PLANNING COMMISSION RESOLUTION NO. 2003-109

**EXHIBIT A
DEPARTMENT OF COMMUNITY DEVELOPMENT
STAFF REPORT
TO THE CITY OF MILL CREEK PLANNING COMMISSION**

CITY FILE NO: Chilelli Preliminary Plat (PP 02-59)

PRELIMINARY PLAT
FOR
CHILELLI PROPERTY

EXHIBIT B

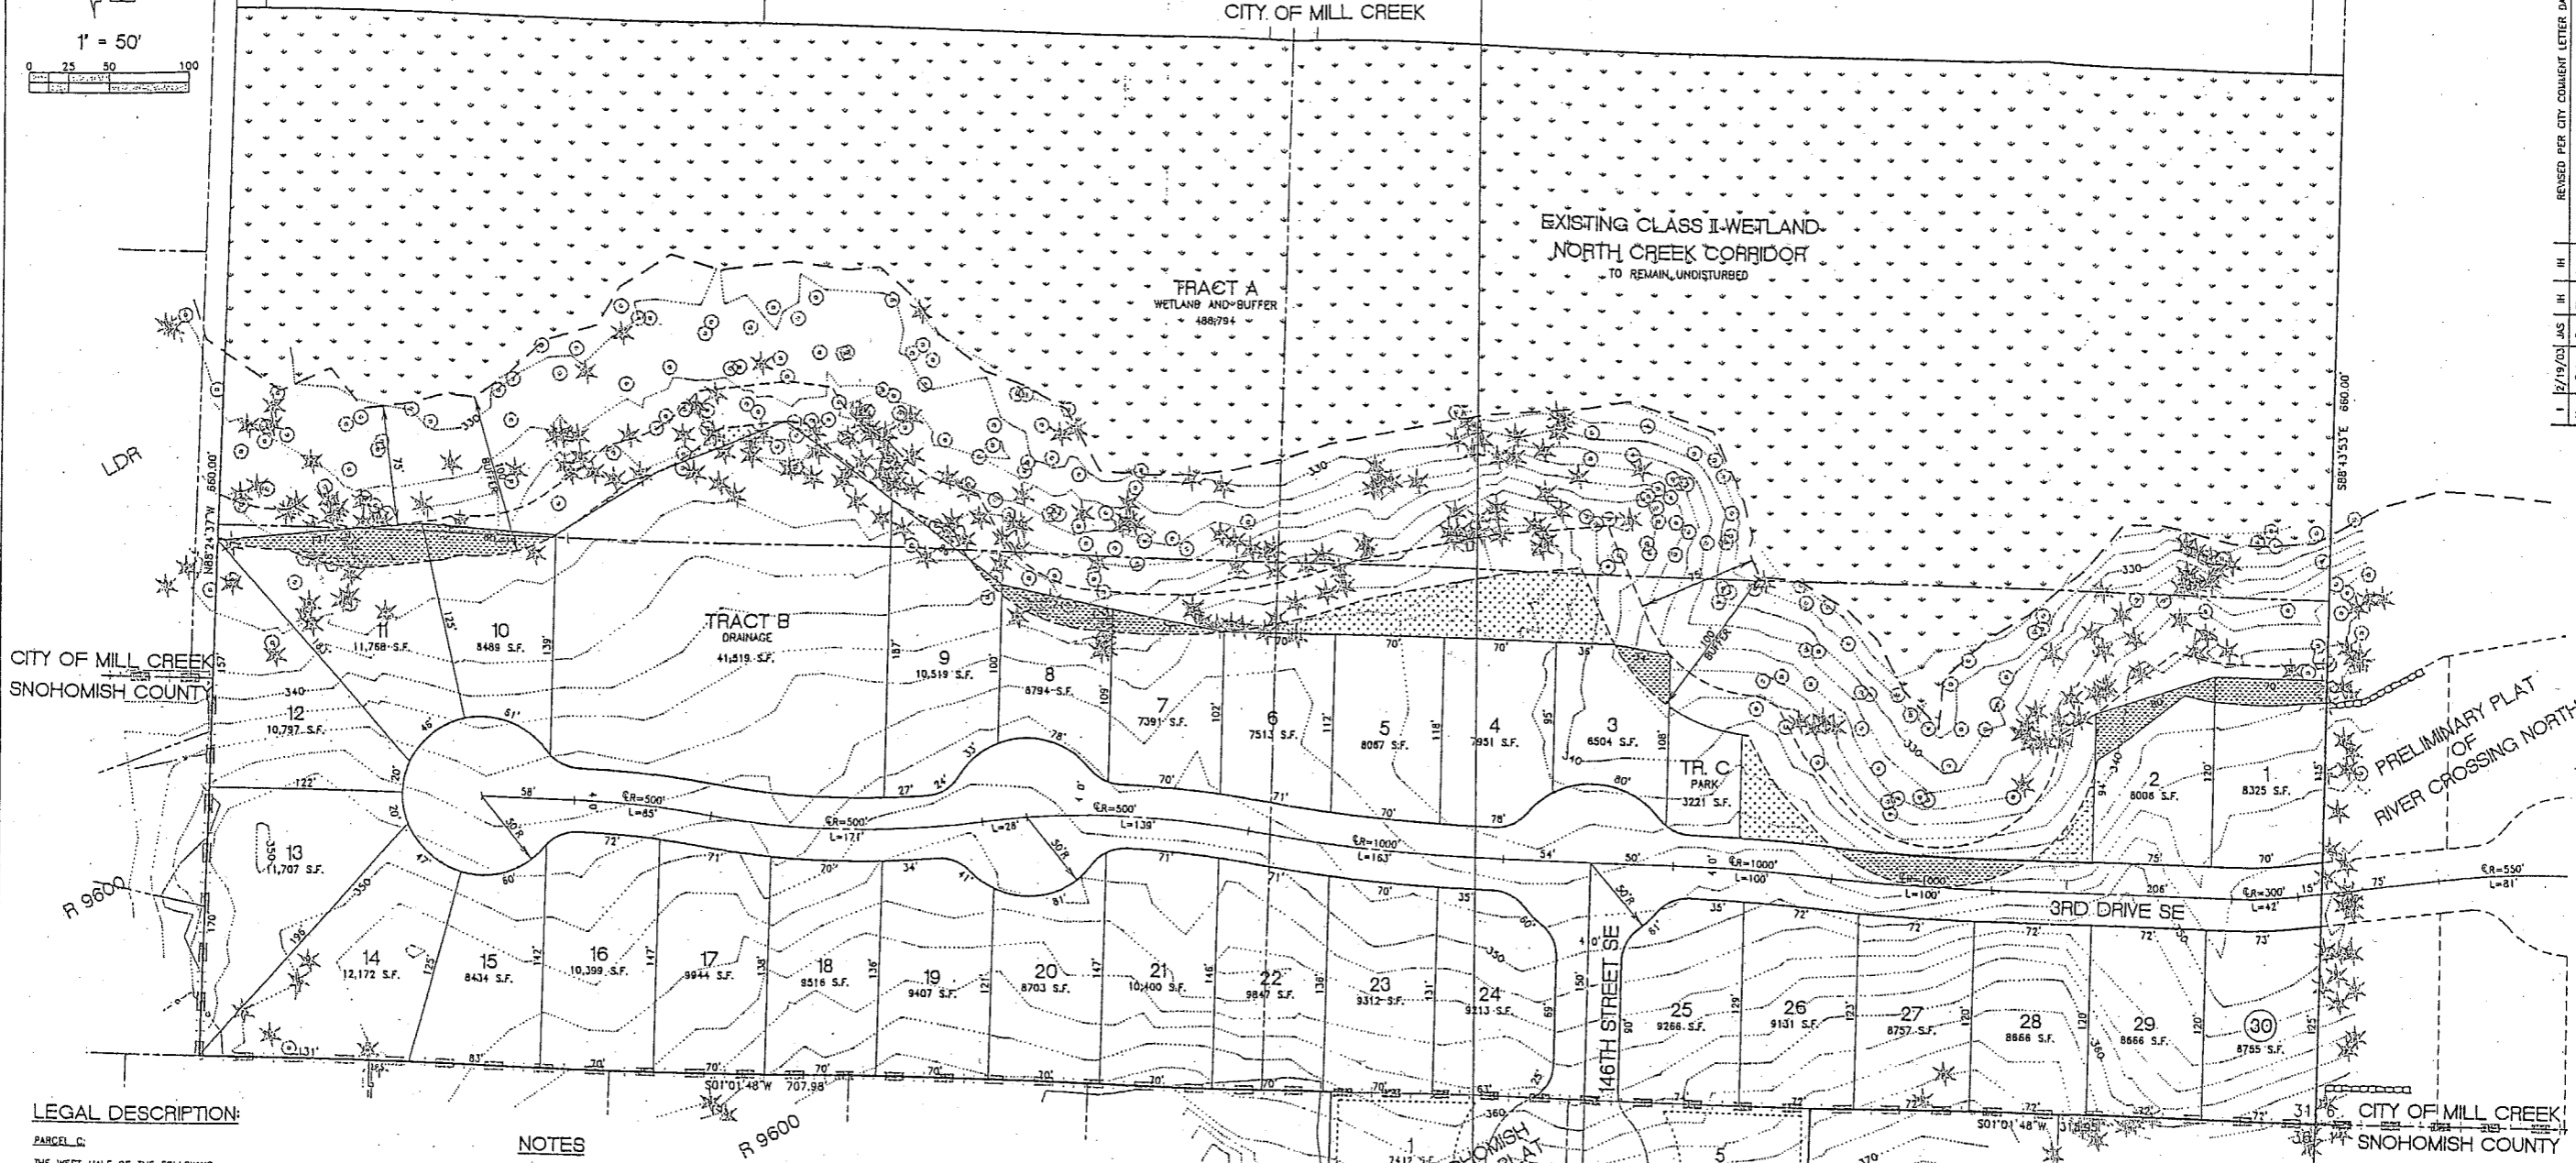
The preliminary mitigation plan submitted by the applicant does not provide adequate information. Thus, for staff to determine if buffer width averaging is appropriate, the MDNS required as a mitigation measure (which is included in the Conditions of Approval) that the applicant provide adequate information to enable the City to determine if buffer averaging is appropriate. In addition, if buffer averaging is permitted, the plat design is required to minimize the need for grading within the buffer and preserve trees and wildlife to the greatest extent possible. If buffer averaging is determined not to be appropriate, adequate area exists within the plat to provide lots that meet the minimum lot size.

To avoid impacts to the wetland buffer, the Conditions of Approval require that a structural retaining wall be constructed instead of a sloped embankment along the east-side of the road, between Lot 2 and Tract 997. A planter strip between the curb and sidewalk will not be required along this section of roadway. Additionally, a traffic guardrail and a pedestrian handrail may be required along this stretch of roadway. Any rail system will be painted to match the existing rail along 3rd Drive SE and 153rd Street SE.

Staff Response – The wetland buffer area consists of mature second growth vegetation. The applicant is proposing to utilize buffer averaging with a minimum dimension of 75 feet. The Conditions of Approval require the applicant to provide buffers consistent with City Code.

1. Development shall occur as portrayed on the Preliminary Plat map dated February 19, 2003, attached as Exhibit B to the Planning Commission Resolution, except as may be modified by conditions imposed by the Planning Commission.
2. The maximum number of building lots shall be 30. Construction shall be limited to one single-family detached residence per lot.
3. The subdivision shall be incorporated into a Homeowners Association, which will be responsible for the maintenance of all privately owned common facilities and landscaping within the traffic islands. The CC & R's shall be submitted to the City for review prior to recording of the Final Plat

10. The applicant shall submit to the City for review and approval a Final Wetland Buffer Mitigation Plan pursuant to Section 18.06.090. Buffer averaging, if approved, shall be consistent with City Code. In addition, the Final Wetland Buffer Mitigation Plan shall address impacts to the wetland buffer as a result of geotechnical test pit sampling and any retaining walls that are constructed. Said plan shall be developed in accordance with Chapter 18.06 MCMC.

- B. The new street width shall match the existing street width of 24 feet curb-to-curb in the adjacent River Crossing North development.
 - C. A structural retaining wall shall be designed and constructed along the east side of 3rd Drive SE between Lot 2 and Tract 997 to avoid impacts to the wetland buffer, unless the Final Wetland Mitigation Plan provides a wetland buffer averaging proposal that meets the requirements of MCMC Chapter 18.06. A five-foot planter strip between the curb and sidewalk is not required between Lot 2 and Tract 997.

- 14.C A structural retaining wall shall be designed and constructed instead of a sloped embankment along the east side of 3rd Drive SE between Lot 2 and Tract 997 to avoid impacts to the wetland buffer, unless the Final Wetland Mitigation Plan provides a wetland buffer averaging proposal that meets the requirements of MCMC Chapter 18.06. A five-foot planter strip between the curb and sidewalk is not required between Lot 2 and Tract 997.
19. All utilities within the project and along all roadway frontage areas shall be placed underground in accordance with City Code. No new utility poles shall be installed in the project site. Appropriate easements or right-of-way for all utilities shall be provided by the applicant and depicted on the Final ~~Binding Site Plan~~ Plat.
